Sunnyside Cogeneration Associates

RE: Sunnyside Cogeneration Associates
Amendment Regarding Culverts and Road
Sunnyside Refuse and Slurry C/007/035

Title: UPDATE CULVERTS AND ROADS - REDLINE SUBMITTAL

Site needs have changed and some culverts removed or added and roads updated

Sunnyside Cogeneration Associates
ROAD CLASSIFICATION MAP

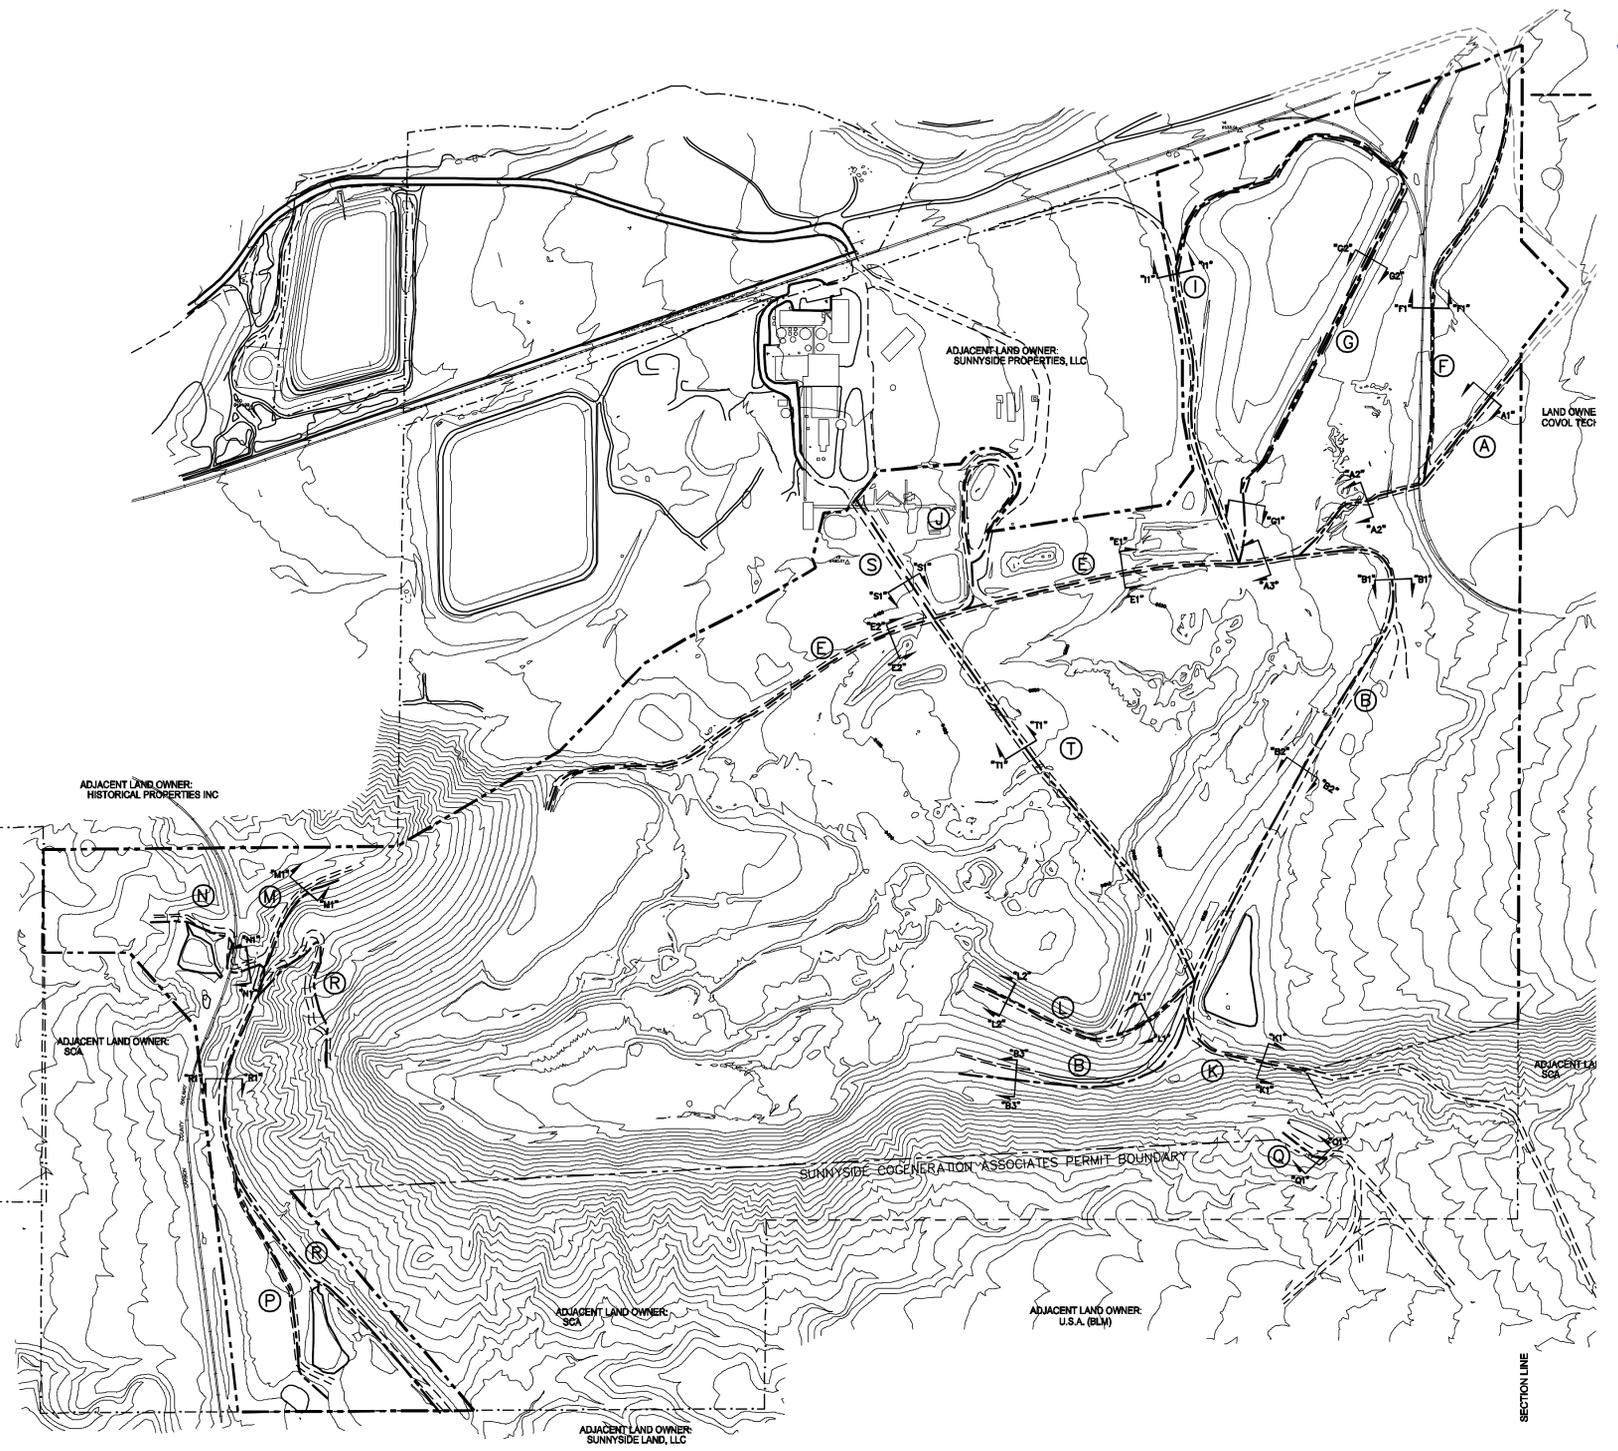
REV	DATE	DESCRIPTION	BY	APP'D
△	7/15	WEST PASTURE AND REFUSE PILE ACCESS ROADS	AH	
△	11/10	BOUNDARY AND TOPO UPDATE	AH	
△	2/07	CHANGE IN ROAD H	AH	
△	9/02	2002 PERMIT RENEWAL	PAM	
△	9/94	CHANGE IN ROAD B AND R	AJZ	
△	2/94	CHANGE ON CLASSIFICATION	AH

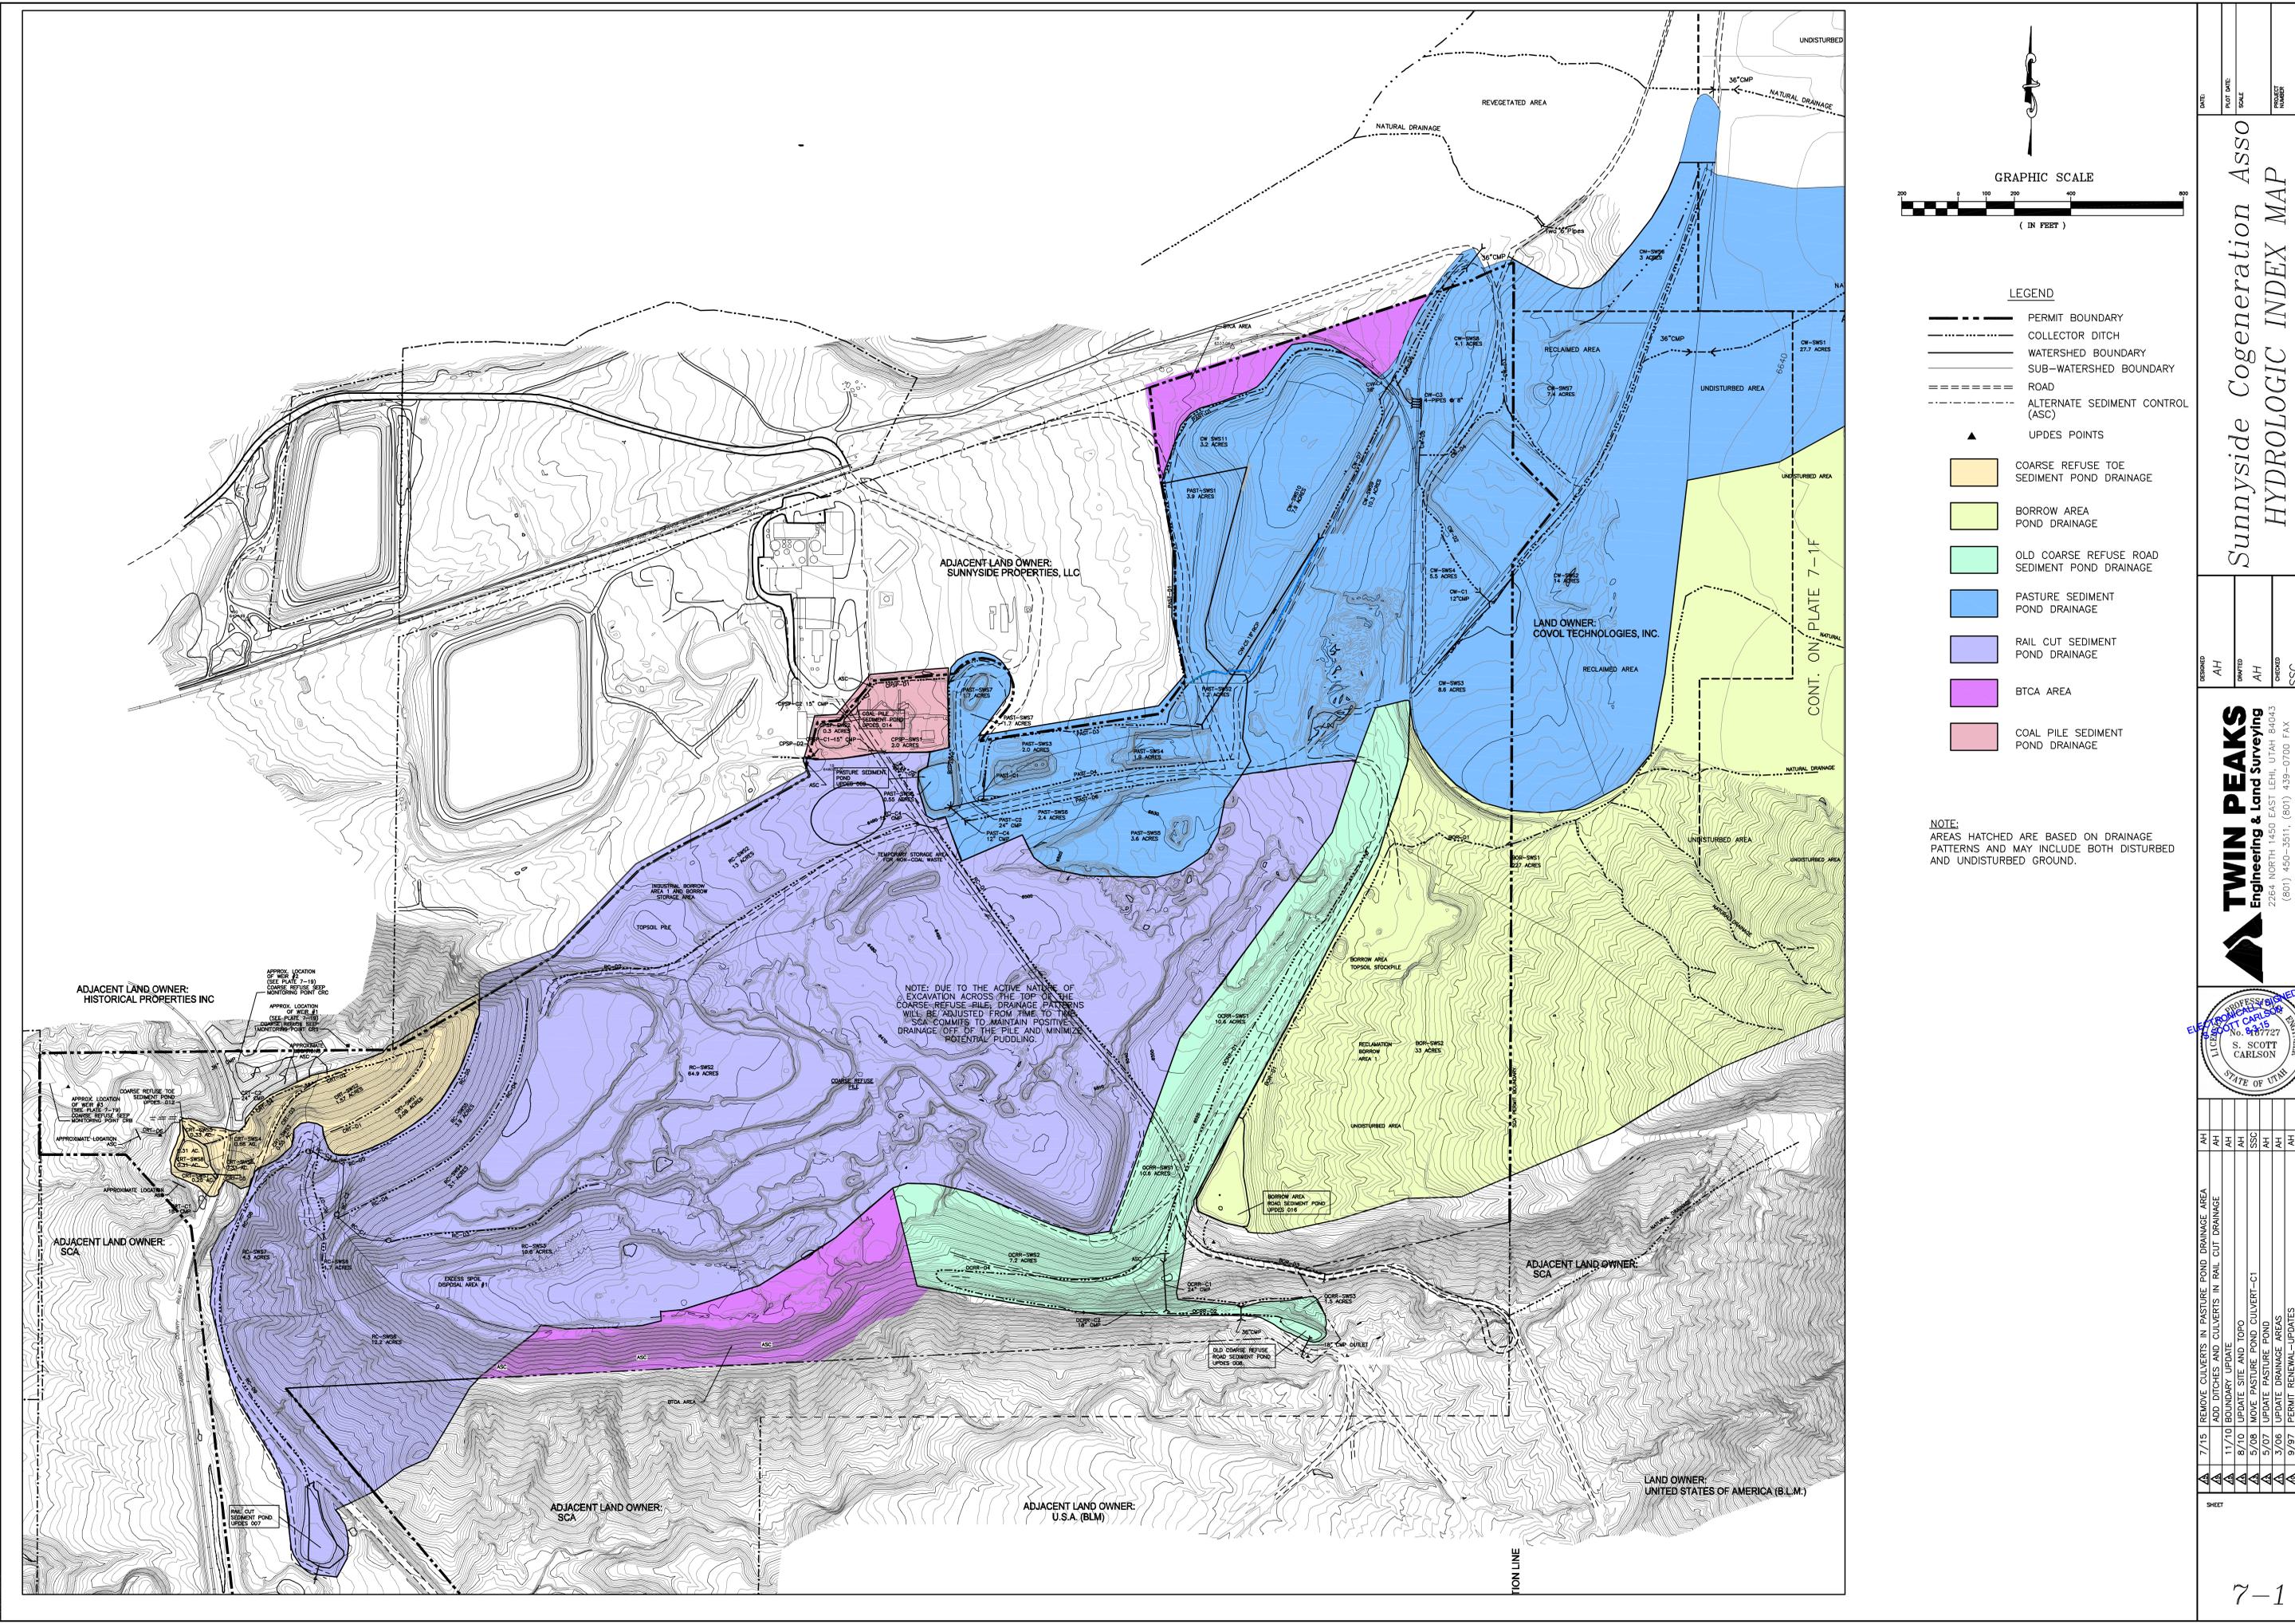
DATE	DESCRIPTION																																
7/15	REMOVE CULVERTS IN PASTURE POND DRAINAGE AREA																																
11/10	ADD DITCHES AND CULVERTS IN RAIL CUT DRAINAGE																																
8/10	BOUNDARY UPDATE																																
5/08	UPDATE SITE AND TOPO																																
5/07	MOVE PASTURE POND CULVERT-C1																																
3/06	UPDATE PASTURE POND																																
9/07	PERMIT RENEWAL-UPDATES																																
DATE	DESCRIPTION																																
7/15	REMOVE CULVERTS IN PASTURE POND DRAINAGE AREA																																
11/10	ADD DITCHES AND CULVERTS IN RAIL CUT DRAINAGE																																
8/10	BOUNDARY UPDATE																																
5/08	UPDATE SITE AND TOPO																																
5/07	MOVE PASTURE POND CULVERT-C1																																
3/06	UPDATE PASTURE POND
